Palo Verde Elementary School

Design Update

Feb. 2021

Updates / Design Revisions

APPROVED SCHEMATIC DESIGN

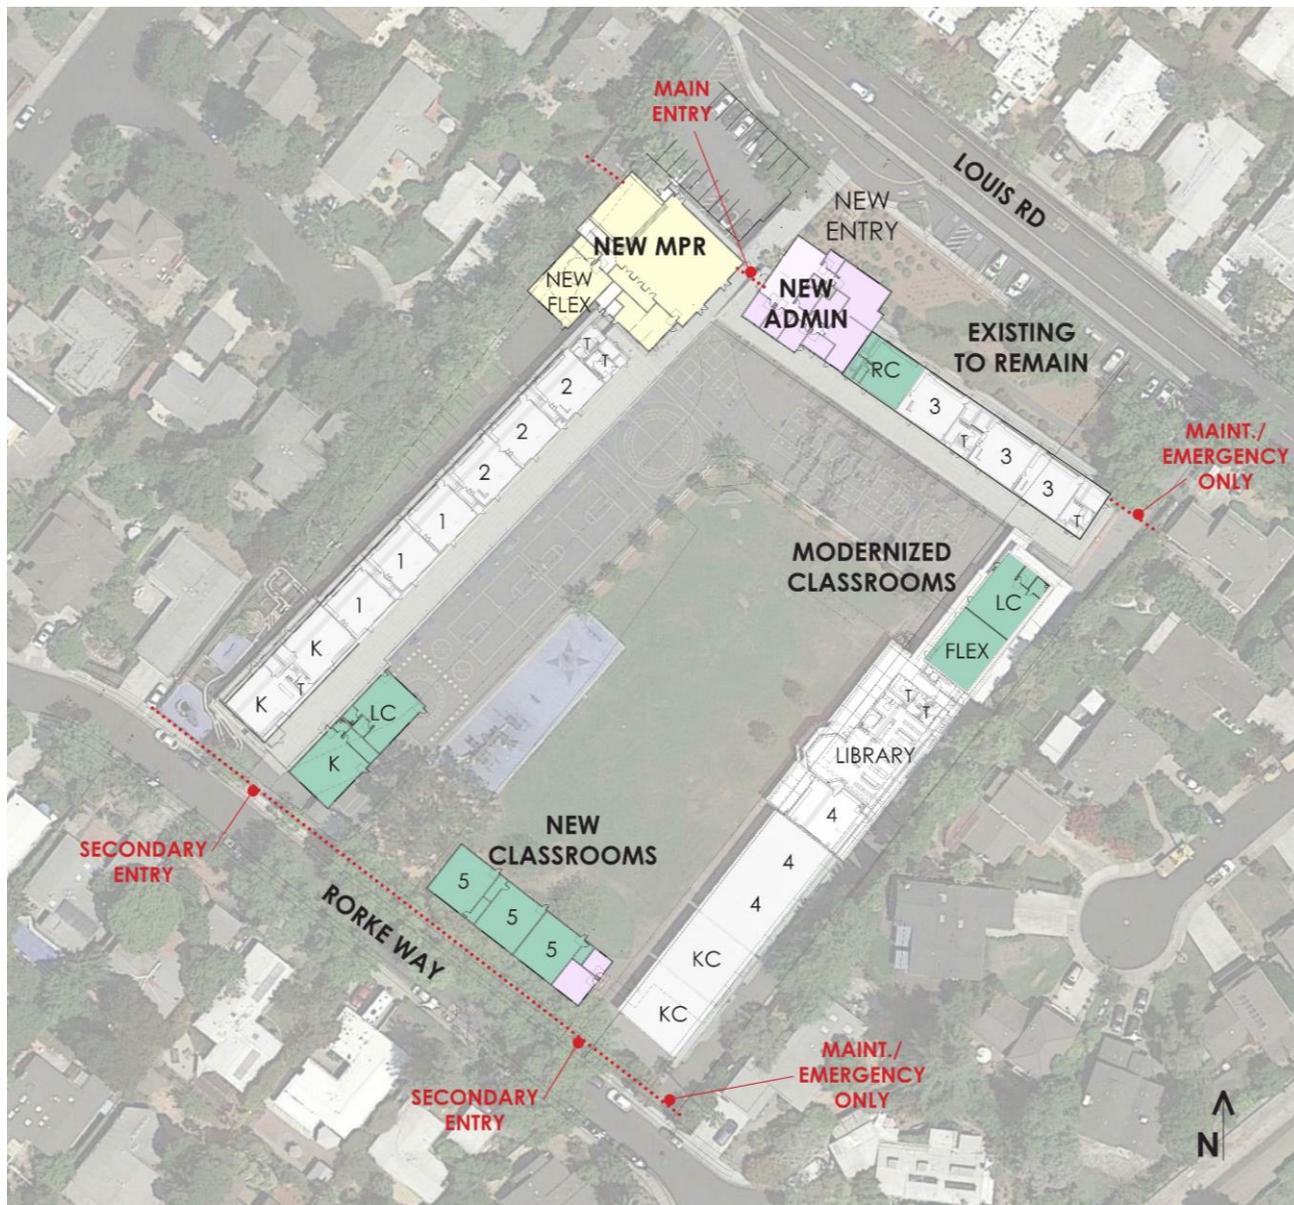
After completing the schematic design, the design team realized that the flood plain (covering the entire PV site) would require new buildings to be raised ~3.5 feet higher than existing buildings. With the schematic design layout, the added ramps and stair would have added several million of cost, plus made the site far less usable.

As such, SVA and the District's team analyzed over 15 different options for the campus program and site plan to minimize the site work and create the most usable site.

1 ADMIN - DEMOLITION PLAN
3/16" = 1'-0"

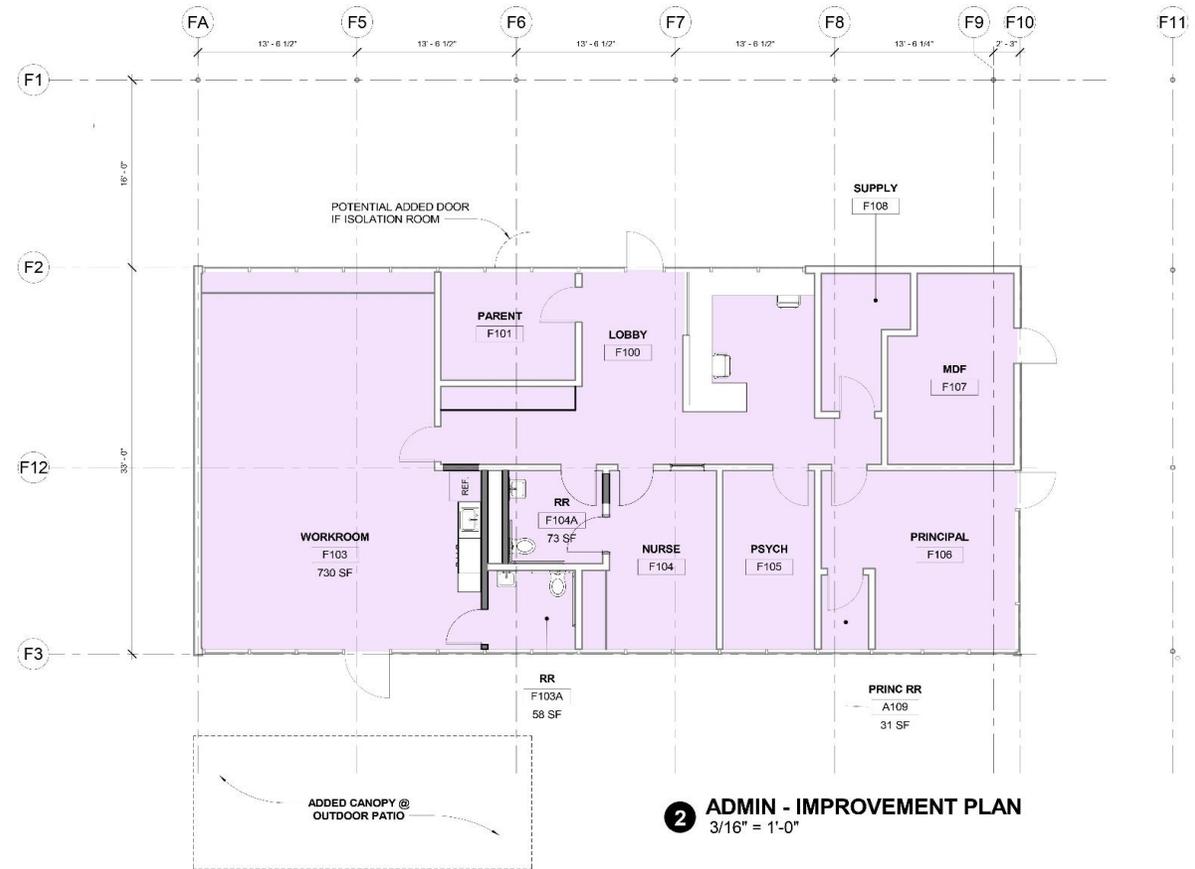
1. MODERNIZE ADMIN RATHER THAN REPLACE.
2. NEW MPR IN LOCATION OF EXISTING MPR.
3. CONSOLIDATE ALL NEW CLASSROOMS INTO NEW BUILDING NEAR RORKE AVE.
